SERVICE DIRECTIVE BULLETIN

SERVICE NOTE NO. 0034

Subject: Copilot's Tail Rotor Pedal Clearance with the Defroster Installation Mount Bolt

Model: F-28A Only

FIGURE 1

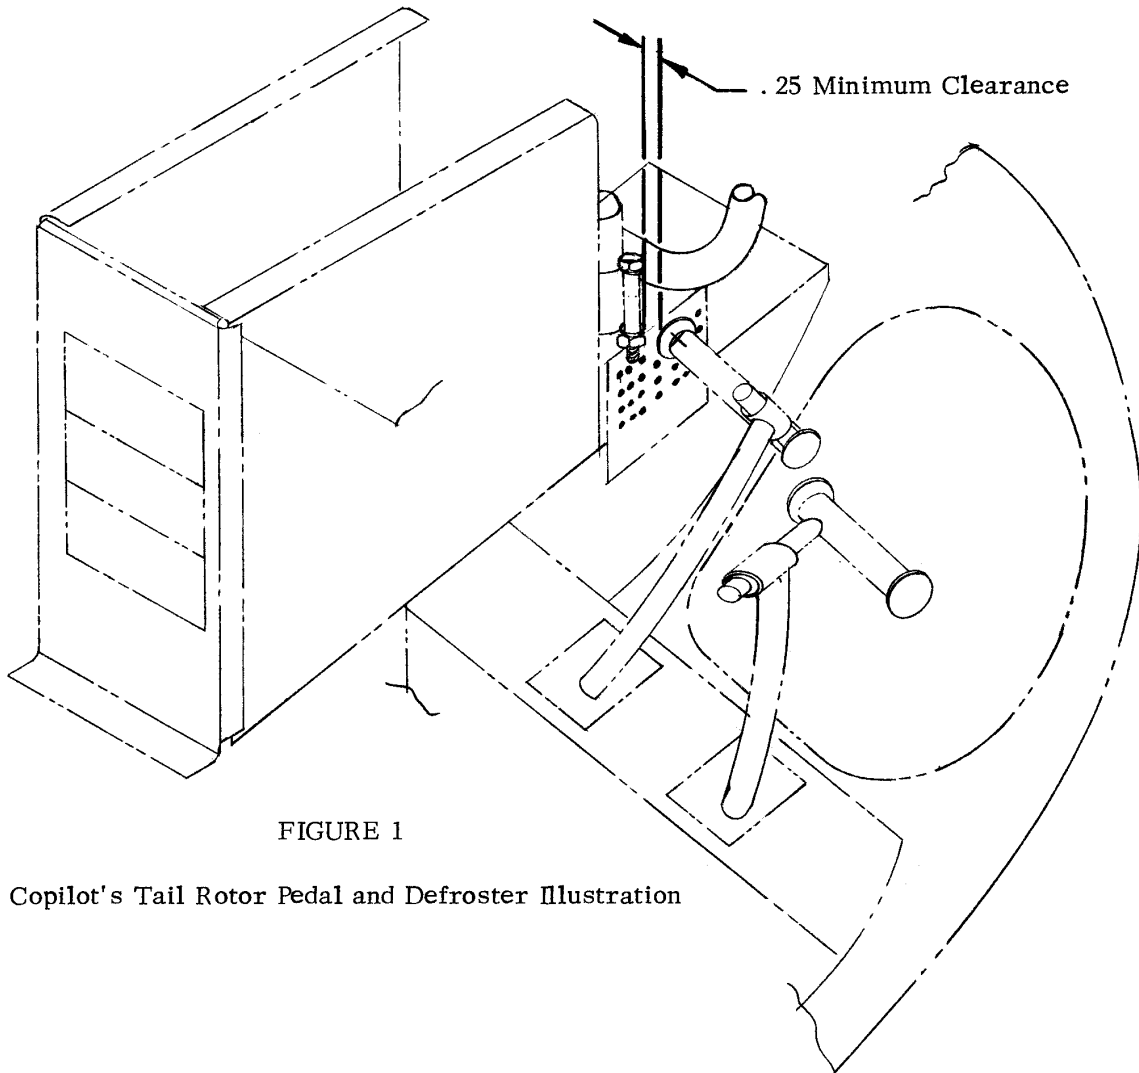
One occurrence has been reported of the copilot's left tail rotor pedal interference with the defroster mount bolt.

1. Push the tail rotor pedals to the full left position.
2. Push the inboard copilot's pedal laterally toward the center of the helicopter to take up system tolerances.
3. Maintaining hand pressure to the left, move the inboard or left tail rotor pedal aft to the stop. The minimum clearance is illustrated on page two, Figure No. 1, of this service note.
4. Items 1, 2, and 3 are to be repeated with the tail rotor pedal in all six of the foot adjustment positions.

If any interferences are found, contact Enstrom Customer Service Department for replacement foot supports (2 required).
